# Access Compliance Report

## Public Rights-of-Way

Intersection ID: 47697	Main Street: NIGHT_HERON_LN	Cross Street: LEES_COURT_ST	Location: E
ADA ID: 681DBBC48EFB	Ramp Type: PerpDiag	Initial Pass/Fail: Fail	Overall Compliance: No
		Severity Score: 10

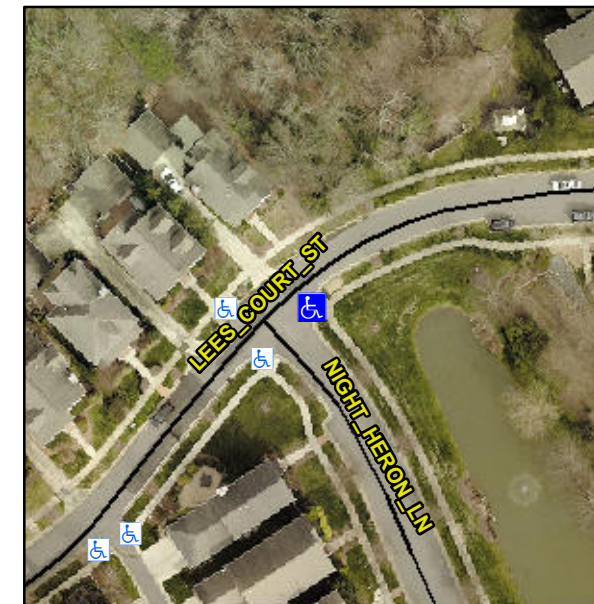
**Not Found, R304.5.1, R304.5.3**

Compliance	Description	Data	Compliance	Description	Data
N/A	Ramp Length (in)	71.0	Yes	Ramp Slope (%)	6.7
No	Ramp Width (in)	44.0	No	Ramp XSlope (%)	3.2
N/A	Flare Type LT	N/A	N/A	Flare Type RT	N/A
N/A	Flare Slope LT (%)	N/A	N/A	Flare Slope RT (%)	N/A
N/A	Flare Traversable LT?	N/A	N/A	Flare Traversable RT?	N/A
N/A	Landing Length (in)	N/A	N/A	DWS Provided?	N/A
N/A	Landing Width (in)	N/A	N/A	DWS Contrast?	N/A
N/A	Landing Slope (%)	N/A	N/A	DWS Length (in)	N/A
N/A	Landing X Slope (%)	N/A	N/A	DWS Full Width?	N/A
N/A	Landing Curb? (Y/N)	N/A	N/A	DWS Offset (in)	N/A
N/A	Shared Landing?	N/A			
N/A	Gutter Ponding?	N/A	N/A	Gutter Slope (%)	N/A
N/A	Gutter Lip Ht (in)	N/A	N/A	Gutter X Slope (%)	N/A
N/A	Painted X Walk1?	No	N/A	Painted X Walk2?	No
	X Walk 1 Direction	To NW		X Walk 2 Direction	To SW
N/A	X Walk 1 Width (in)	N/A	N/A	X Walk 2 Width (in)	N/A
	X Walk 1 Slope (%)	1.8		X Walk 2 Slope (%)	0.5
	X Walk 1 X Slope (%)	0.5		X Walk 2 X Slope (%)	2.6

**Remove & Replace Curb Ramp With Two New Directional Ramps or Equivalent.**
